Serial No. 06-140D
KPS/LIC/CDS: R9
Docket No. 50-305
License No. DPR-43

DOMINION ENERGY KEWAUNEE, INC.
KEWAUNEE POWER STATION
RESPONSE TO NRC QUESTIONS REGARDING LICENSE AMENDMENT REQUEST
215, "MODIFICATION OF INTERNAL FLOODING DESIGN BASIS"

**RESPONSE TO NRC QUESTIONS REGARDING
KEWAUNEE LICENSE AMENDMENT REQUEST 215
“MODIFICATION OF INTERNAL FLOODING DESIGN BASIS”**

Figure 8-1

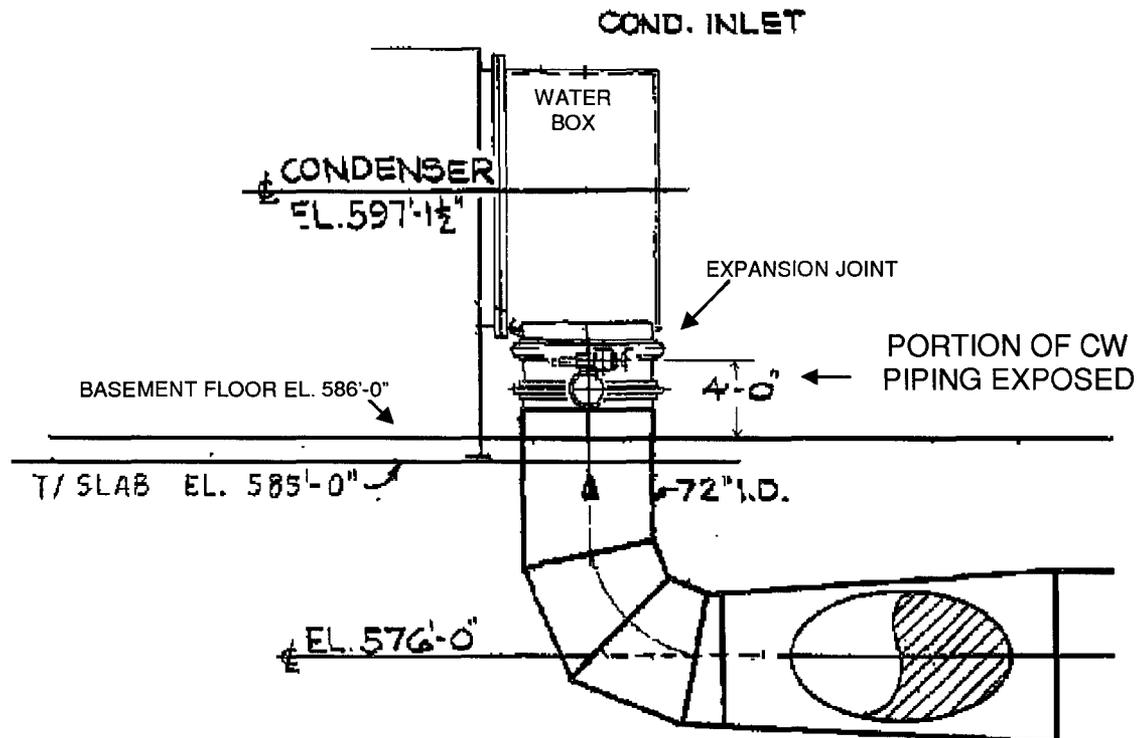
Question 8

The Circulating Water (CW) system piping between the condenser and the turbine building basement floor (586 foot elevation) was excluded as a flooding source. The piping is clearly rigid in that it originates from the concrete floor beneath the building and is built into the concrete slab. On the inlet side of the condenser (Figure 8-1), four 72-inch diameter pipes extend approximately 4 feet above the floor to rubber inlet expansion joints, which connect to the condenser inlet waterboxes. On the outlet side of the condenser, four 72-inch diameter pipes extend approximately 1.7 feet from the floor to the rubber outlet expansion joints and approximately 2.75 feet from the expansion joints to the condenser outlet waterboxes. The expansion joints limit transfer of forces from the condenser to the CW piping. The inertial response of a 4-foot or a 2.75-foot, 72-inch diameter pipe is rigid and the stresses are negligible.

Each 72-inch condenser outlet pipe that extends from the bottom of the outlet expansion joints to the turbine building basement floor is approximately 1.7-feet in length. This section of pipe was not independently analyzed, but is bounded by the condenser inlet piping analysis, which is for a longer section of pipe.
